ARC REGIONAL REVIEW NOTICE

ARC REVIEW CODE: R1410071

Name of Proposal: Atlanta Media Center

TO:	Jon Tuley, Land Use Division
FROM:	Daniel Studdard, Transportation Access and Mobility Division
DATE: SUBJECT:	October 1, 2014 Transportation Division Review of DRI # 2443 Project: Atlanta Media Center County: Gwinnett Location: Block bordered by Crescent Drive, Jimmy Carter Boulevard/SR 140, Brook Hollow Parkway/Best Friend Road, and Nancy Hanks Drive Analysis: Expedited Non-Expedited Image: Context State Sta
CC :	David Haynes TAMD

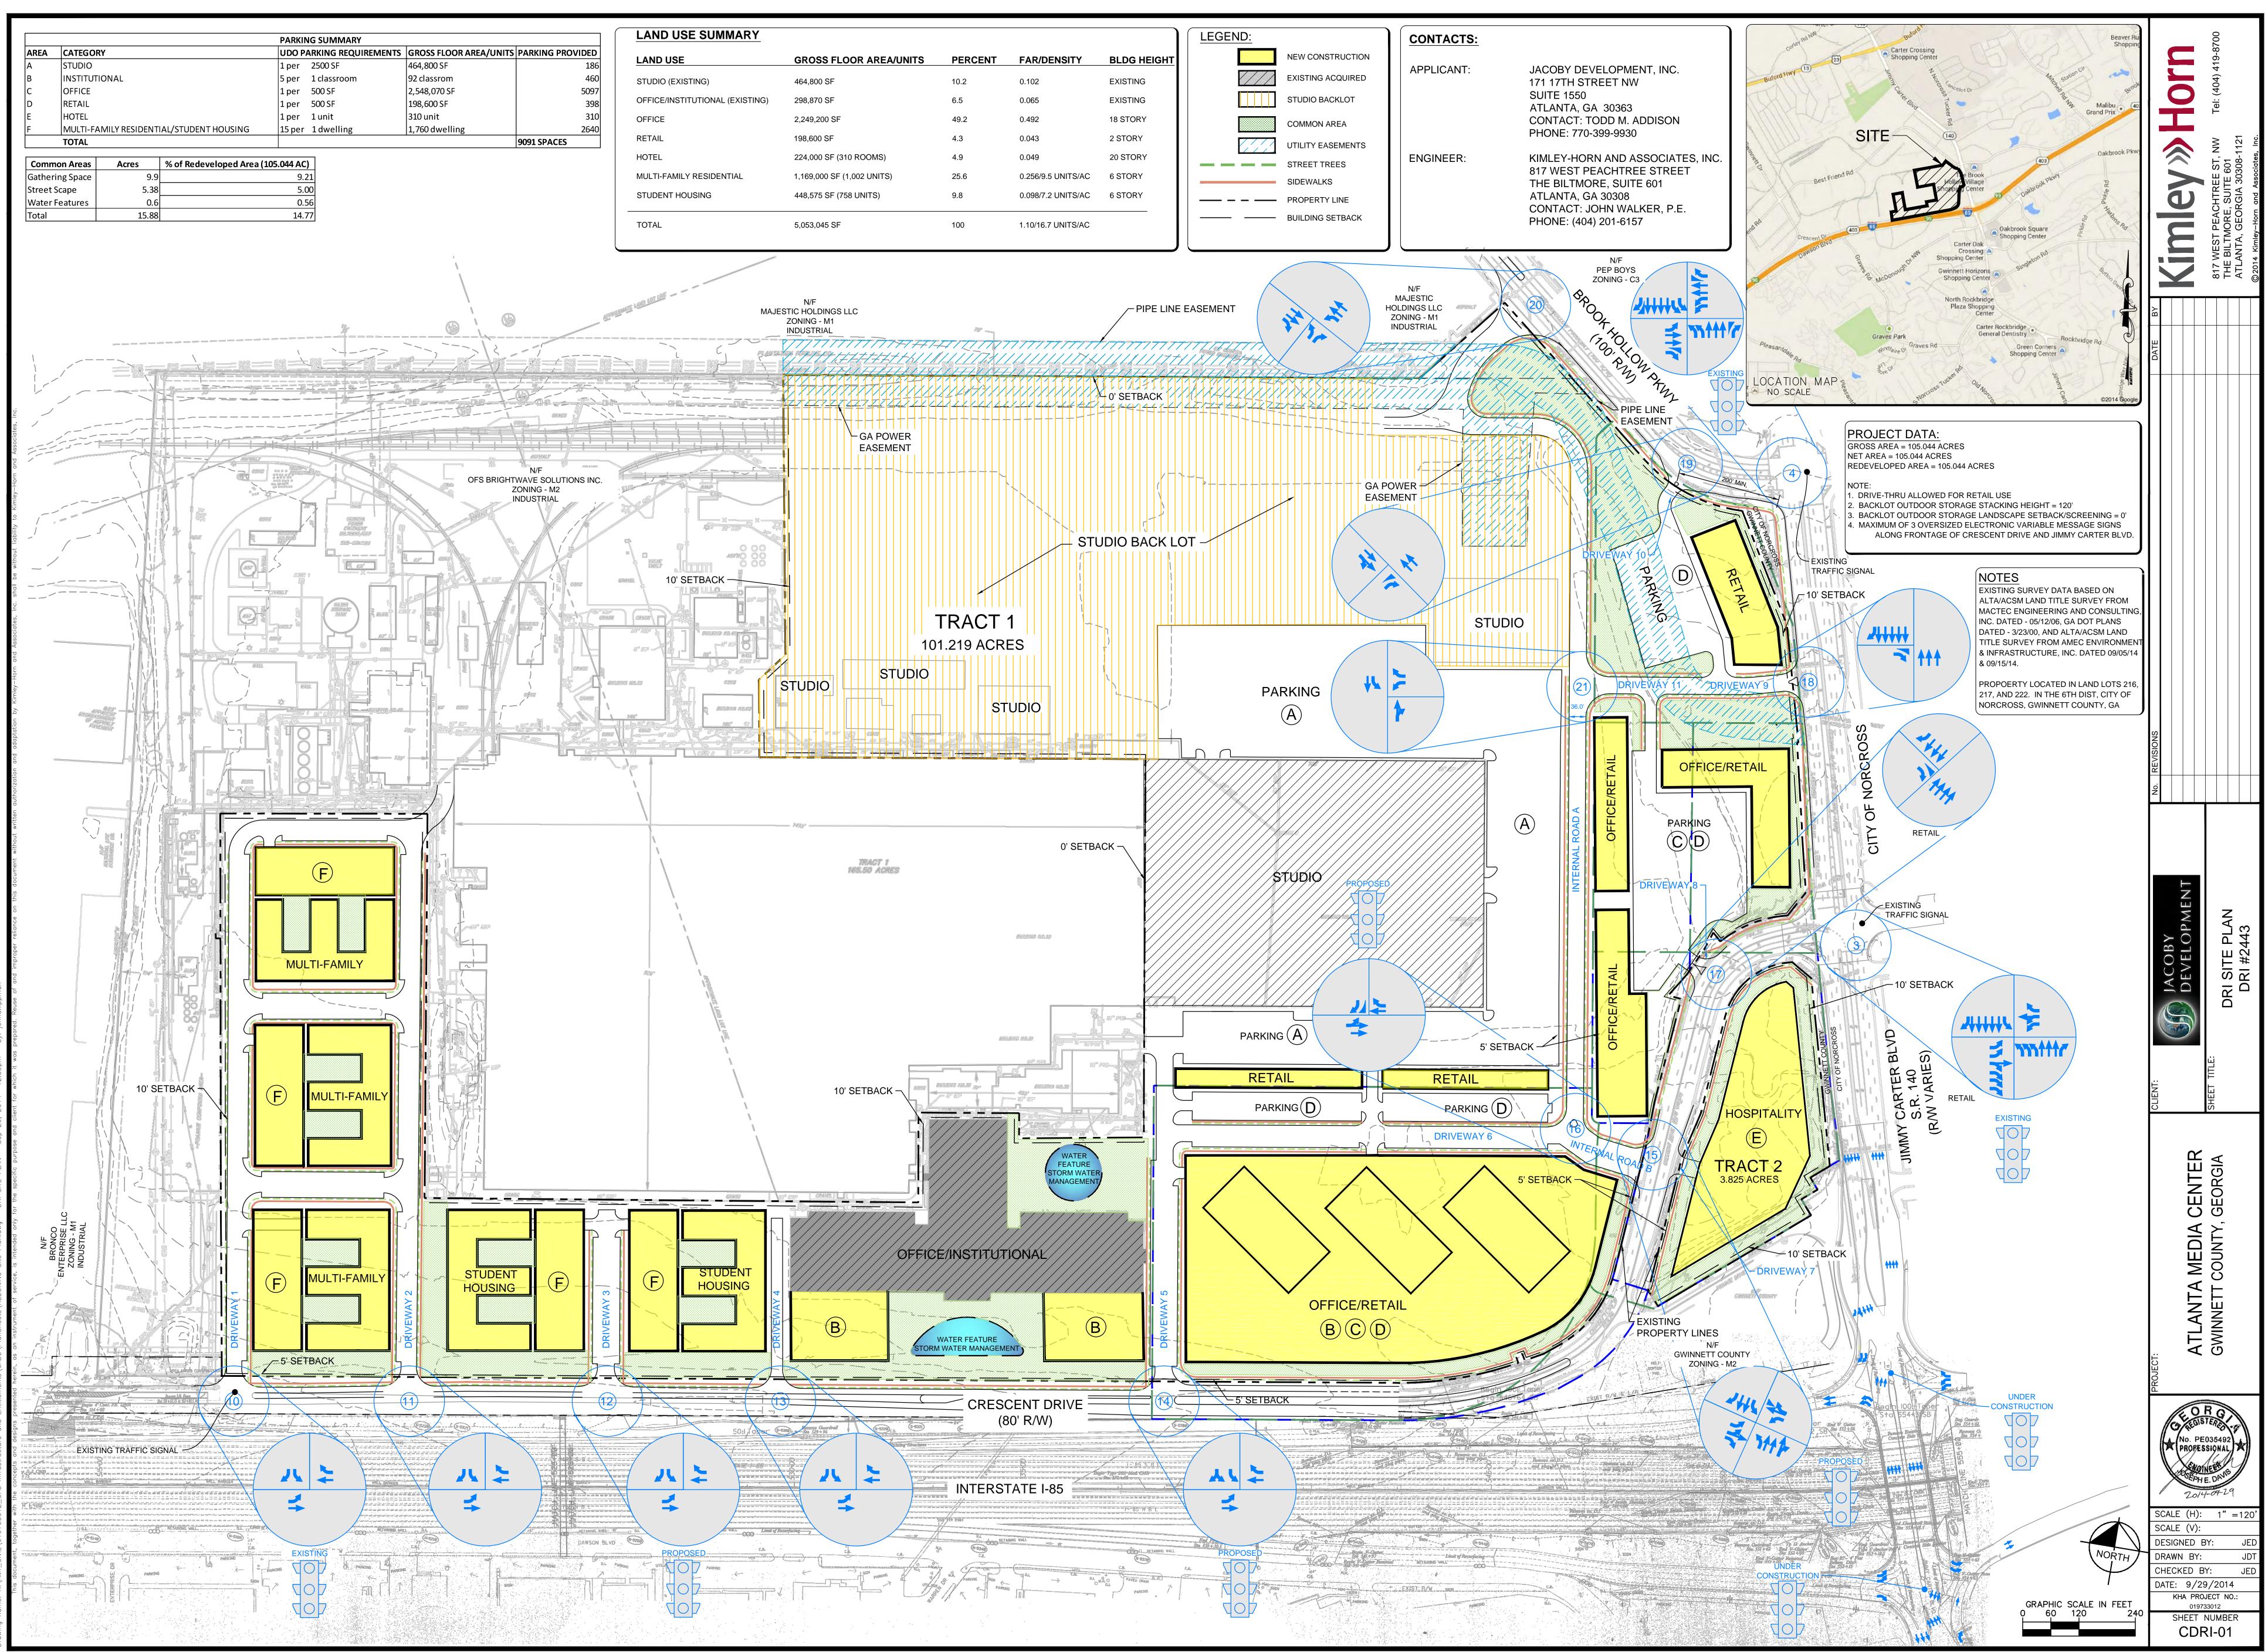
The DRI traffic study assumes an alternative transportation mode reduction of 10.0%. To achieve this level of alternative mode use, adequate bike and pedestrian facilities are needed along adjacent roadways as well as within the site. The DRI site plan identifies locations of sidewalks but does not show bike facilities.

- The DRI traffic study assumes an alternative transportation mode reduction of 10.0%. To achieve this level of alternative mode use, adequate bike and pedestrian facilities are needed along adjacent roadways as well as within the site. The DRI site plan identifies locations of sidewalks but does not show bike facilities.
- The applicant should review the *Indian Trail/Jimmy Carter Pedestrian & Bike Connectivity Plan, December 2012*, as it relates to the proposed DRI site and adjacent area.
